Reference No. 007097

Re: Comments and Responses

Re: Pontiac Centerpoint Campus (Pontiac West) RCRA Corrective
Action – USEPA Facility ID No. MID005356902
Summary for AOI #50 -DUCO Stores – Building 34
660 South Boulevard East, Pontiac, Oakland County, Michigan

figure 3

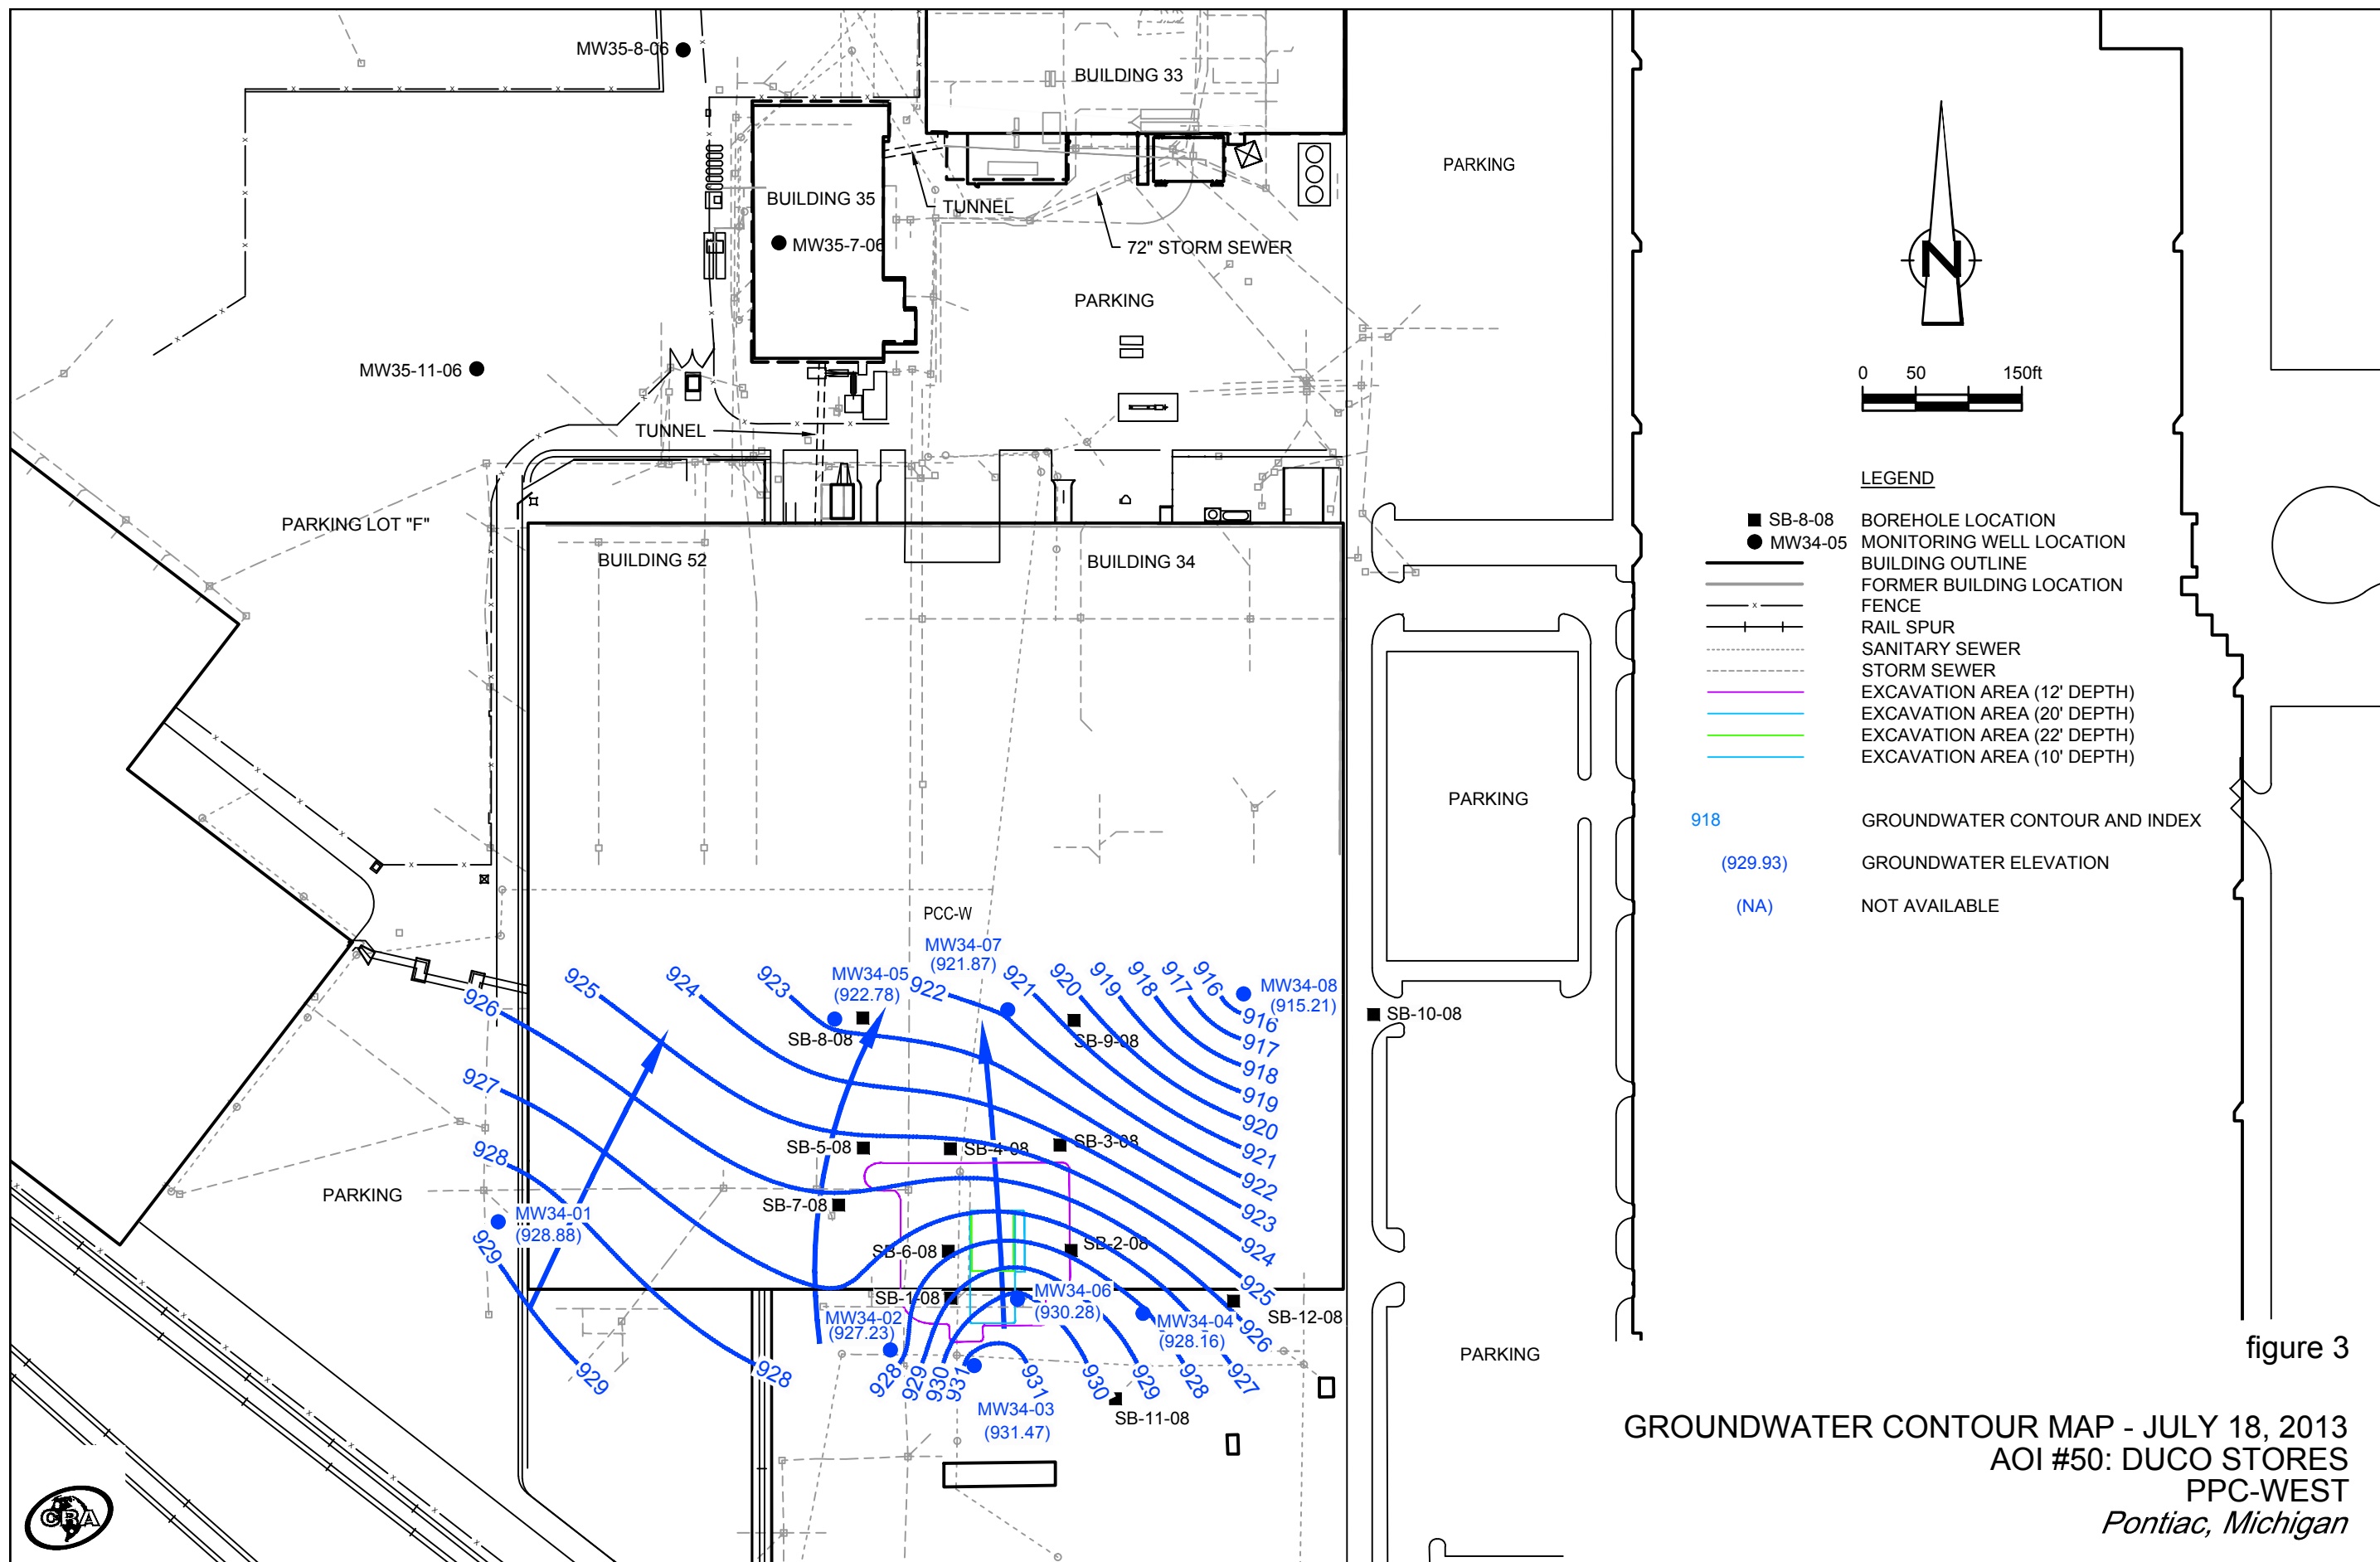
- A figure showing groundwater flow direction in the area.

An updated groundwater contour map from water levels collected on July 18, 2013 is presented as Figure 3 of the attached letter report.
